FNDC Rezoning Hearing 15C - evidence review

Victoria Yorke and Andrē Galvin, Submitter 530 and Andrē Galvin, Submitter 567

Prepared for	Far North District Council
Project Number	FNDC-J014
Revision	A
Issue Date	27 August 2025
Prepared by	Mat Collins, Associate Transportation Engineer

Figure 1.2 Austroads Guide to Traffic Management Part 6 Figure 3.25 showing warrant for CHR at approximately 10 veh/hr

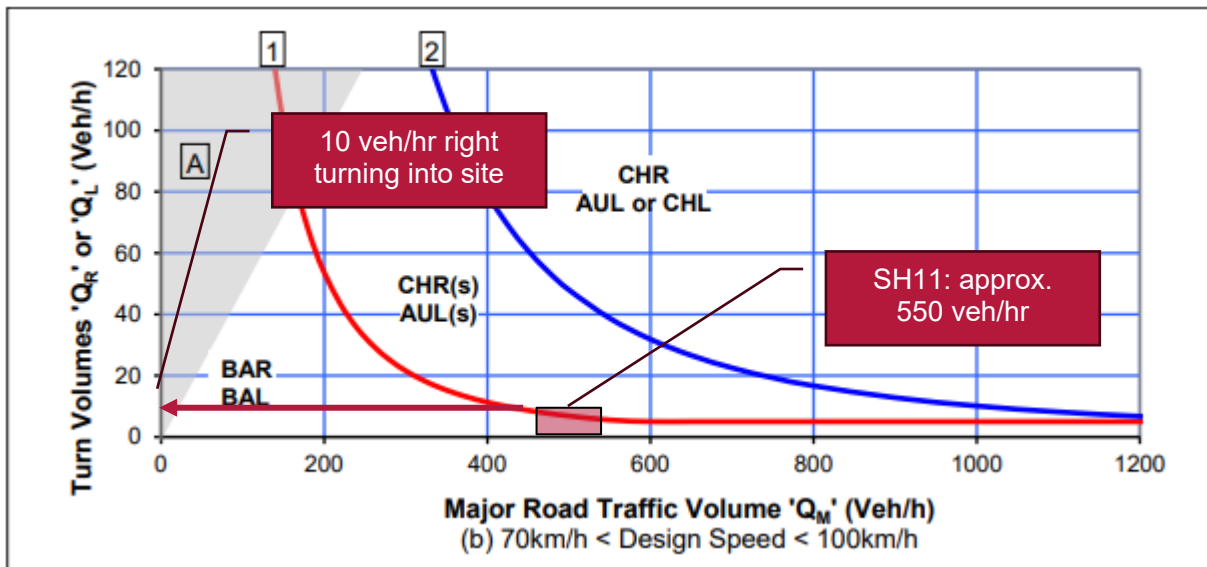
- Based on Austroads Guide to Traffic Management Part 6, a Channelised Right Turn (CHR) treatment may be required. With an estimated 550 veh/hr on SH11, a CHR would be required if the number of right turning into the site access exceeds approximately 10 veh/hr, as shown below Figure 1.2.
